Access Report

**Multi Dwelling Narrabeen**  
140-142 Ocean Street  
Narrabeen NSW 2101

For: Trio Industries Pty Ltd  
Ref: PAA\_24271

Development application documentation for the proposed Narrabeen residential development located at 140-142 Ocean Street, Narrabeen NSW 2101, has been reviewed against current accessibility legislation.

Figure 2 | Overall Site Plan

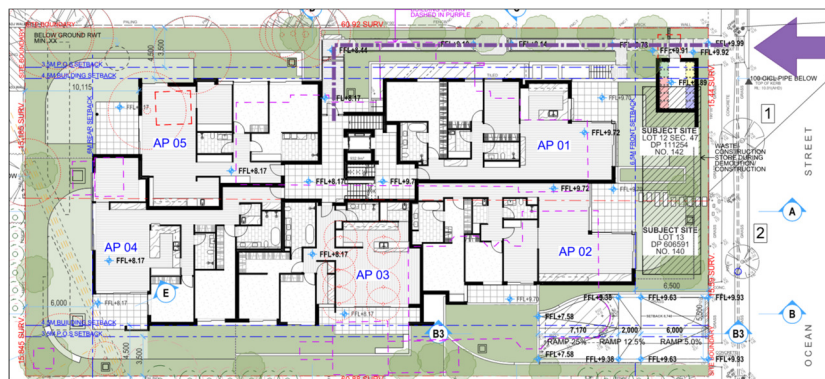
An accessible path of travel is provided to the building entrance from the allotment boundary along Ocean Street via a formed footpath. Site levels indicate that on-grade access is achievable with walkways and ramp facilitating an accessible path of travel to the building entrance.

Footpaths that form the approach to the building are a dimensioned at least 1000mm wide. Site levels indicate a level surface is achievable. Ramps and walkways are provided to facilitate access.

Straight ramps are provided at the front entrance. The configuration of the ramps are in keeping with accessibility requirements including length between landings, and the provision of handrails with extension to both sides.

Ensure tactile indicators are provided at the top and bottom of the ramp and that kerb rails are provided as necessary where ramp is not enclosed during detailed design.
